**From:** Caron Greenough <Caron.Greenough@nzta.govt.nz>  
**Sent:** Monday, 30 June 2014 12:03 p.m.  
**To:** Phil Chatterley  
**Subject:** RE: M2PP - Otaihanga Roundabout Operational Issues

In response to your request for comments regarding the issues that have arisen at the Otaihanga roundabout, the RSA team has reviewed your e-mail and the two drawings and our comments follow. However, it must be noted that these comments are made without the benefit of on-site observations and as such constitute just our initial thoughts prior to undertaking the post construction safety audit in July.

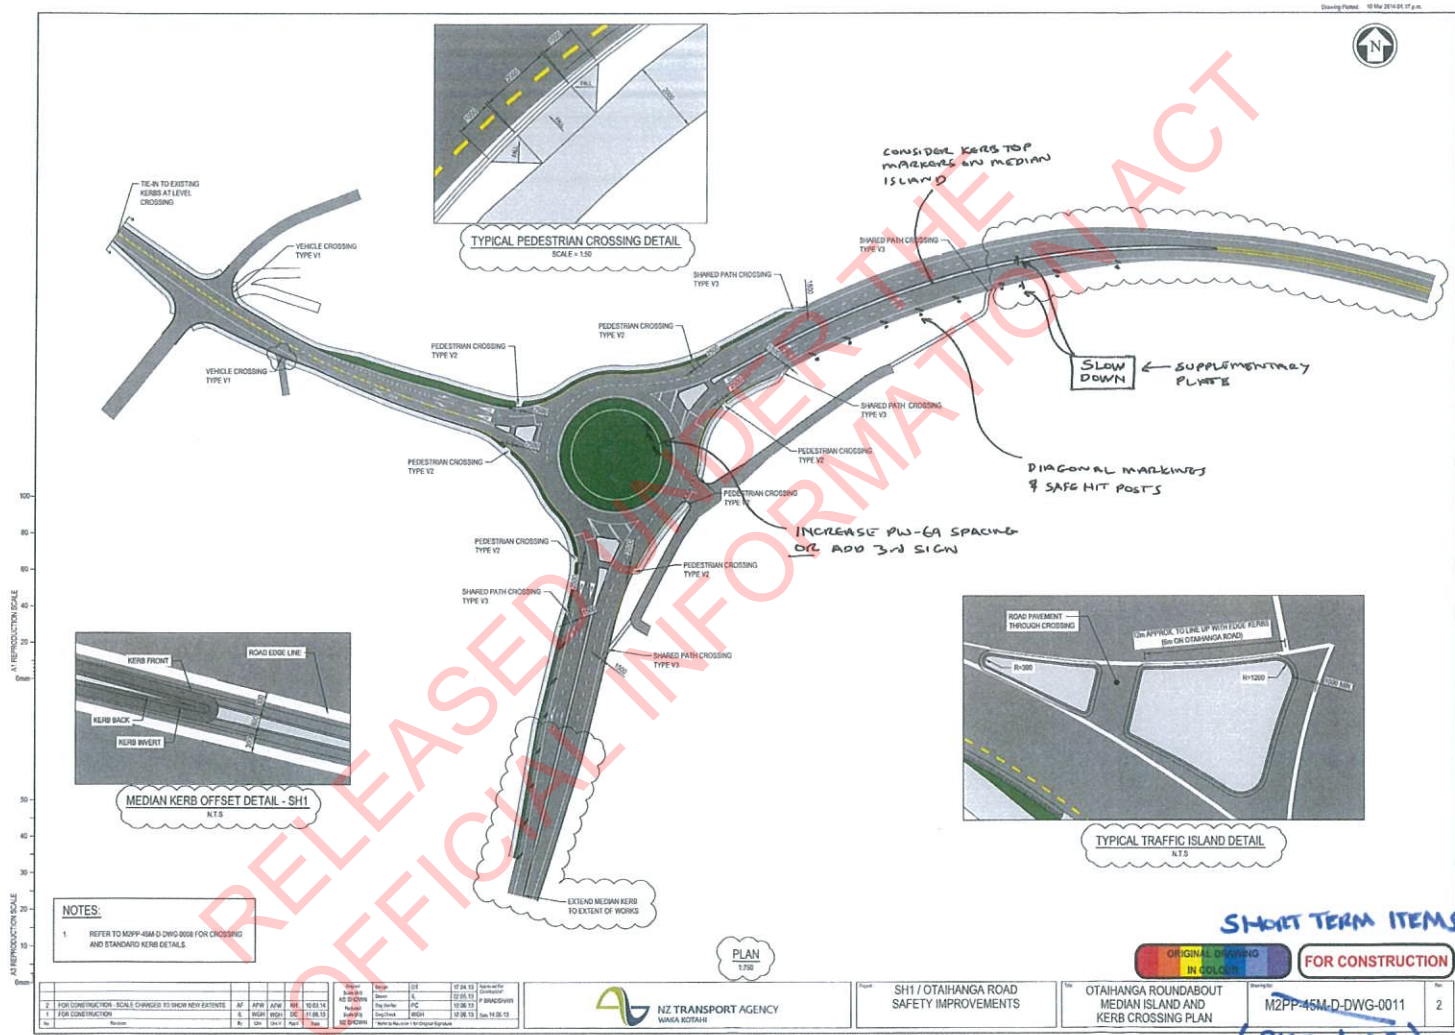
Please find attached for your comment the Revised Otaihanga Roundabout Road Marking Drawing.

OTAHANGA ROUNDABOUT MEDIAN ISLAND AND KERB CROSSING PLAN

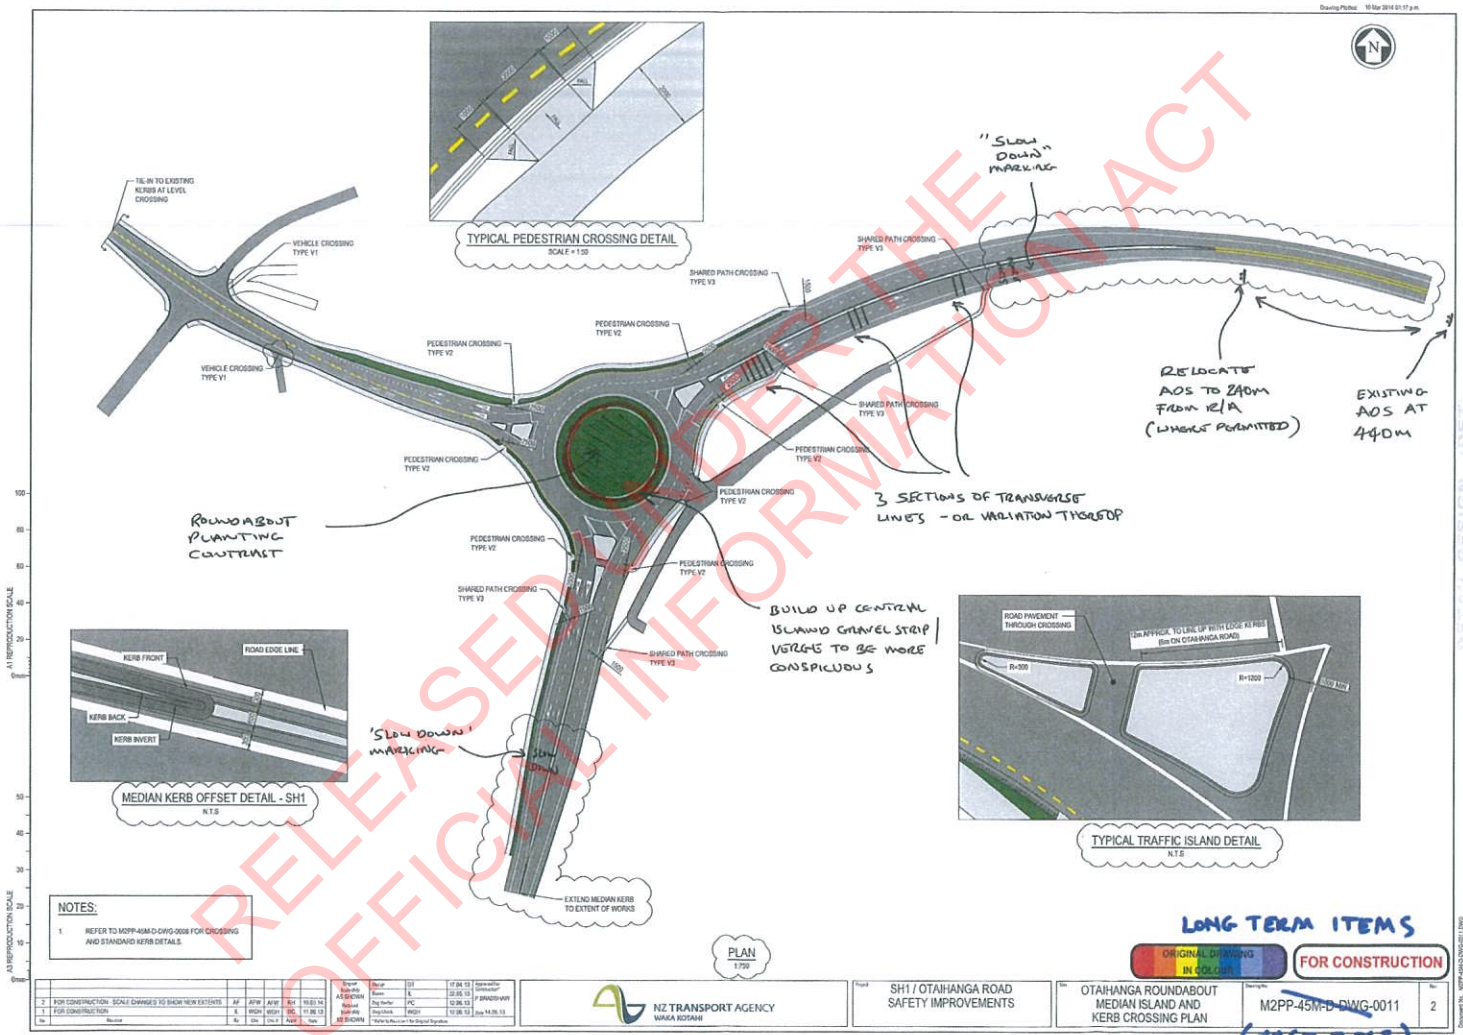
**SHORT TERM ITEMS**  
 ORIGINAL DRAWING IN COLOR FOR CONSTRUCTION

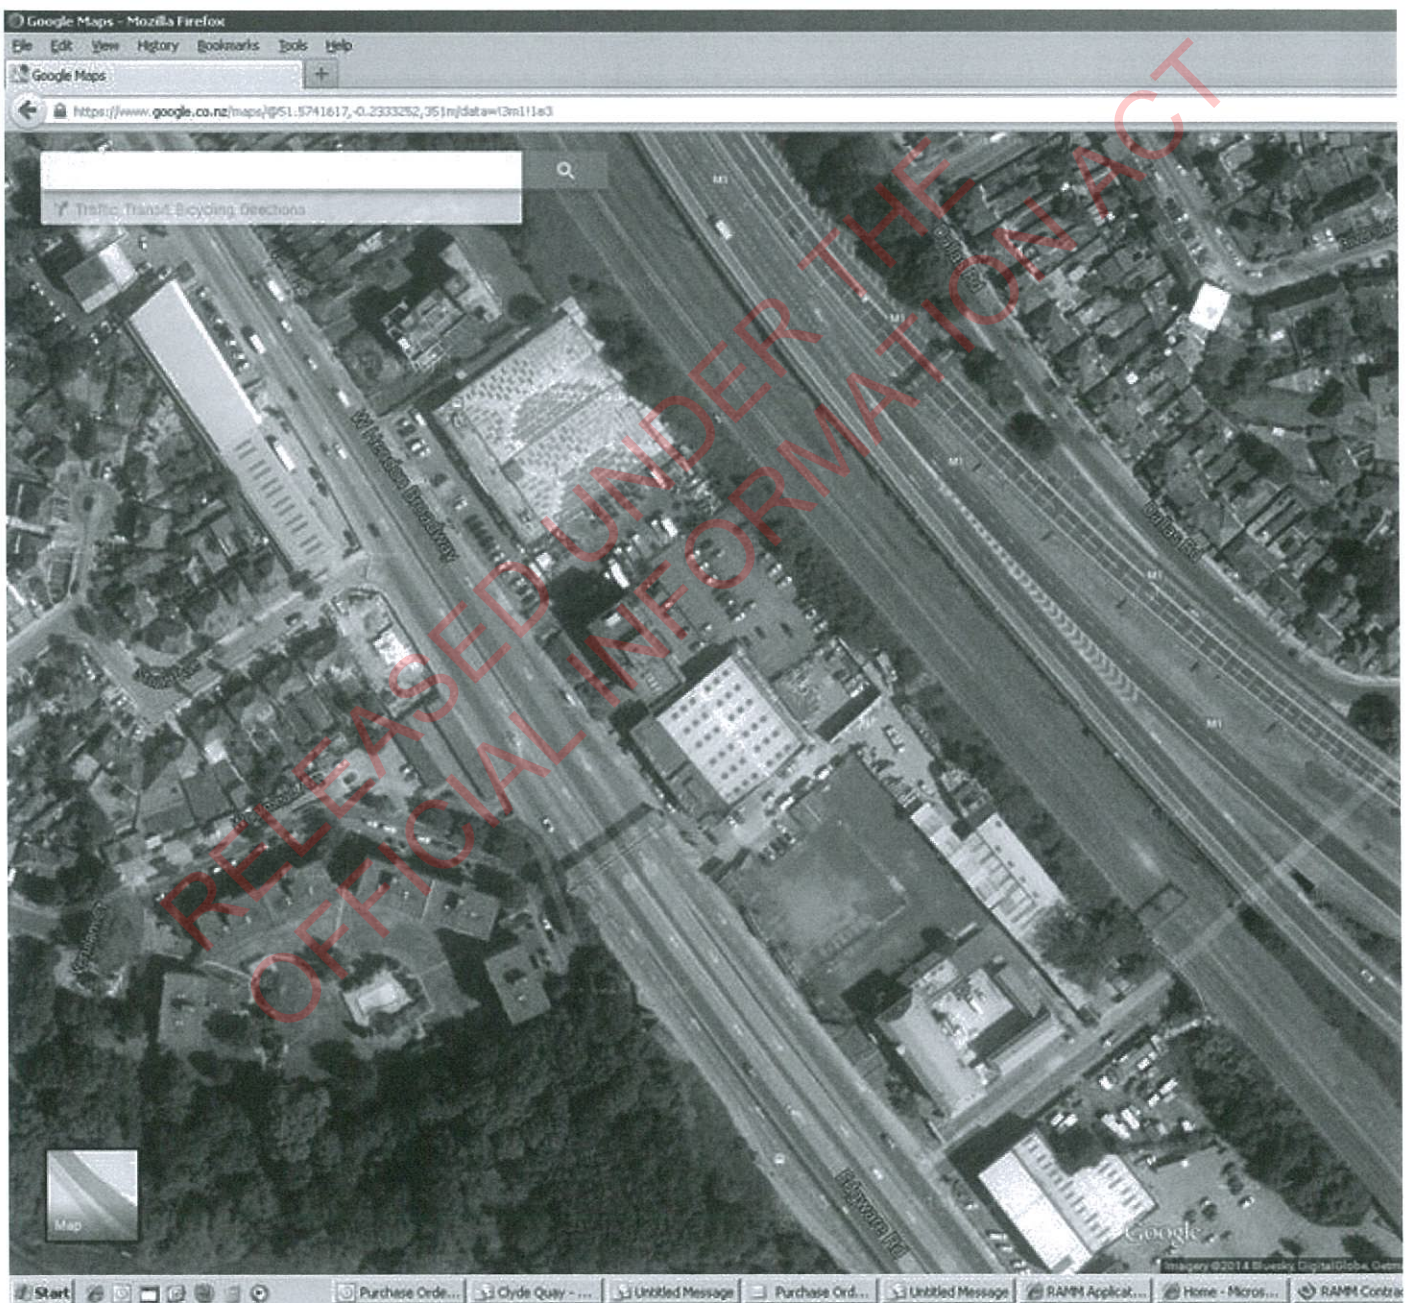
Below is an aerial pic of Staples Corner which lies at the foot of the M1 in London. The intersection sees it join a very large roundabout connecting it to a major arterial road which circumnavigates London. No, not the M25 but the A406 instead. The problem the road authorities had was that this road has a 2km downslope and a road speed of 110k (more realistic user speed 125k) and many was the occasion when people had to slam on the brakes to stop.

The countermeasure was to paint yellow lines across the carriageway at set spacing. Once your eyes acknowledged the regularity in the spacing the buggers then went and started painting the lines ever so slightly closer together – you can see this very evident in the picture. What this would achieve is to fool the road user in to thinking that their speed was not reducing as much as they first thought – the effect was to just be slightly more focussed on braking. The spacing changes were subtle and the effects on users really good and it is clear that they are still happy with what started as a trial what must be over fifteen years ago.

Whilst it is slightly more complex than getting a some tins of paint and a line marking team, it could be worth floating as an idea to promote road user safety. With NZTA as part of the Alliance it might be that bit simpler to initiate such a discussion.
